INDESIT company

Model type:
IDE100EU

Commercial code:
F030666

Notices

N1045072FIG1

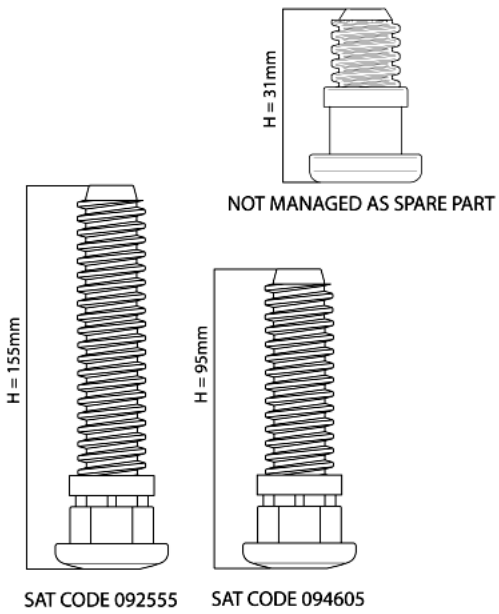
N1045072: Introduction of fixed rear foot H=31mm on free-standing models.

From serial no. 40218.0001, free-standing dishwashers affected by this modification have been equipped with new fixed rear feet (H=31mm).
The new foot replaces the adjustable one (H=155mm) Service code 092555; on the EVO3 range with TurboDry the new foot replaces the adjustable foot (H=95mm) Service code 094605.
The Spare Part Warehouse will continue to manage only 155mm and 95mm adjustable feet as they are interchangeable with the fixed 31mm foot.
The three feet are shown in illustration N1045072FIG1.

N1045080FIG1

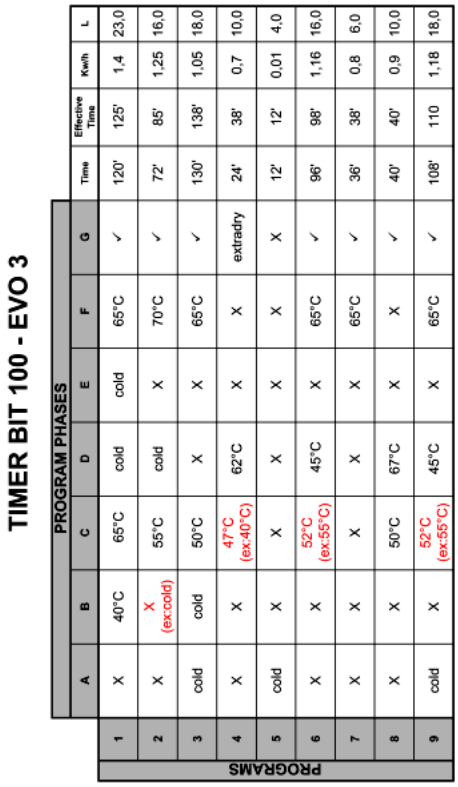
n1045080: Modification of front feet on free-standing DW.

From serial no. 40413.0001, free-standing dishwashers affected by this modification have been equipped with new front feet Service code 109991 in place of 056414.
The new foot is shown in fig. N1045080FIG1.

N1045083FIG1

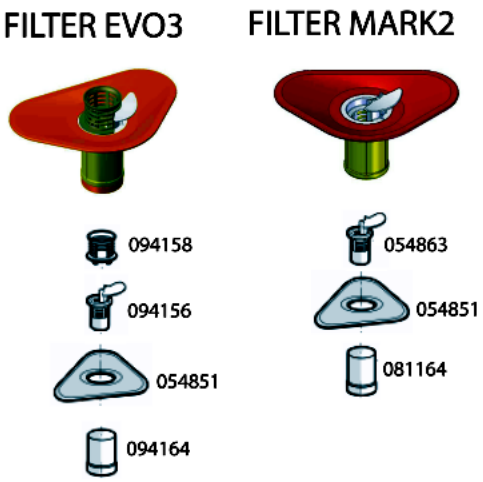
n1045083: Modification of filters on EVO3 60 cm dishwashers

All dishwasher models affected by this modification have been equipped with the items listed below, in order to solve the drain pump clooging problem.

Introduction of:
Cylindrical plastic filter code 081164
Central filter code 054863

Elimination of:
Cylindrical plastic filter code 094164
Central filter code 094156
Central filter grid code 094158

The modification has been introduced progressively, starting from serial no. 40516.0001.

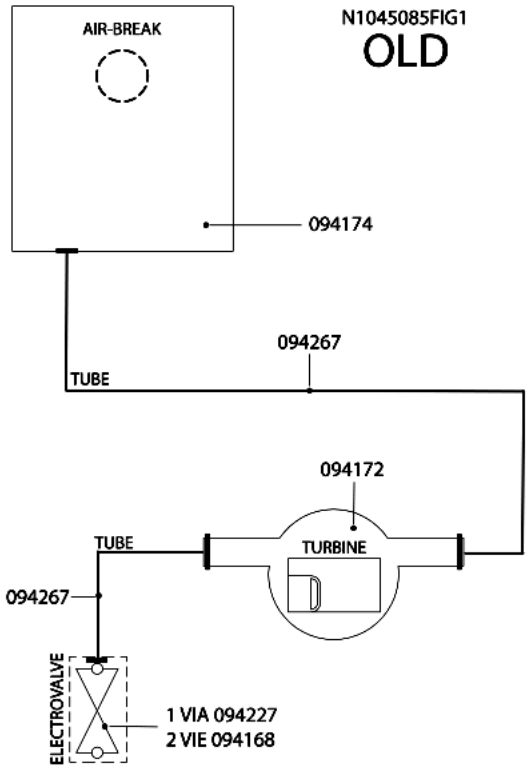
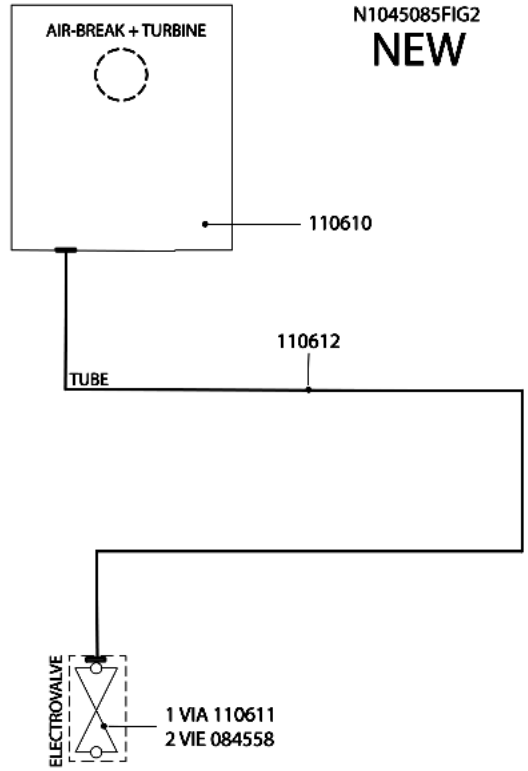
n1045085: Introduction of new litre counter turbine integrated on air-break.

All dishwashers affected by this note have been equipped with a new litre counter turbine on the air-break.
Picture N1045085FIG1 illustrates the premodification structure, picture N1045085FIG2 the new structure.

Items affected by the modification.

AIR-BREAK:
new 110610;
premodification 094174;
the new item features a new integrated litre counter turbine and its water supply hose has a smaller diameter.

LITRE COUNTER TURBINE code 094172 has been eliminated.

SOLENOID VALVES:
new:
1-WAY code 110611;
2-WAY code 084558(Rohs 143737);
premodification:
1-WAY code 094227;
2-WAY code 094168;
the new solenoid valves have a smaller diameter drain hose fitting.

HOSES:
new solenoid valve hose/air-break code 110612;
premodification turbine hose/air-break code 094267;
premodification solenoid valve hose/air-break code 094267;
the new hose has a smaller internal diameter.

WIRING:
the litre counter turbine connecting cable is longer, but since the connector is the same, the new item can be used in place of the premodification one.
